**McCombie Smith Architects**  
71 Main Street , Greetham , Rutland , LE15 7NJ

Site visit with Noel McLaughlin, structural engineer  
14 March 2023

Structural issues have been identified by Palmers of Oakham , who have been instructed to clear out the building in preparation of carrying out remedial works once approved. All works potentially require Listed Building Consent if the works are anything more than repair and maintenance.

X20 with missing bearing,

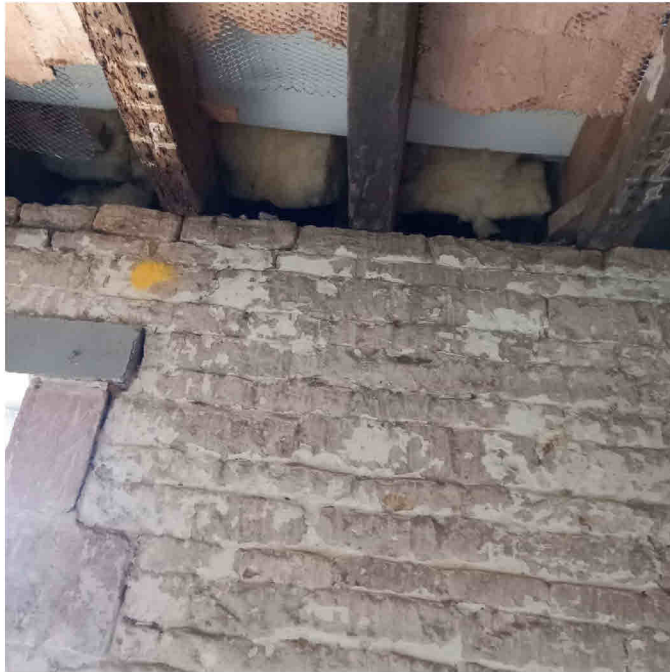
X20 modern floor beam unsupported at one end; bearing has been removed and end bearing been reduced by end cutout. Currently supported by timber props  
Action X20: reinstate bearing.

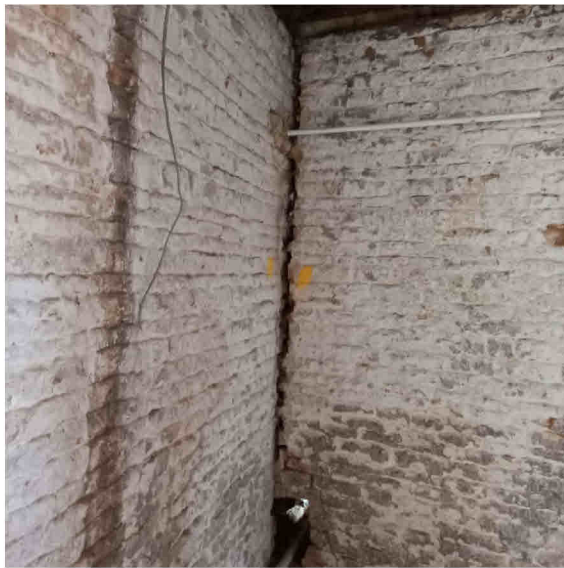
X21 Masonry bearing for lintels over opening questionable.  
Action X21: rebuild bearing

X22 Floor joist above ceiling joists undersized  
Action X22: strengthen existing joists as required.

X23 Bearing for floor joists above (ceiling joists) minimal.  
Action X23: sister joists to extend to provide sufficient bearing.
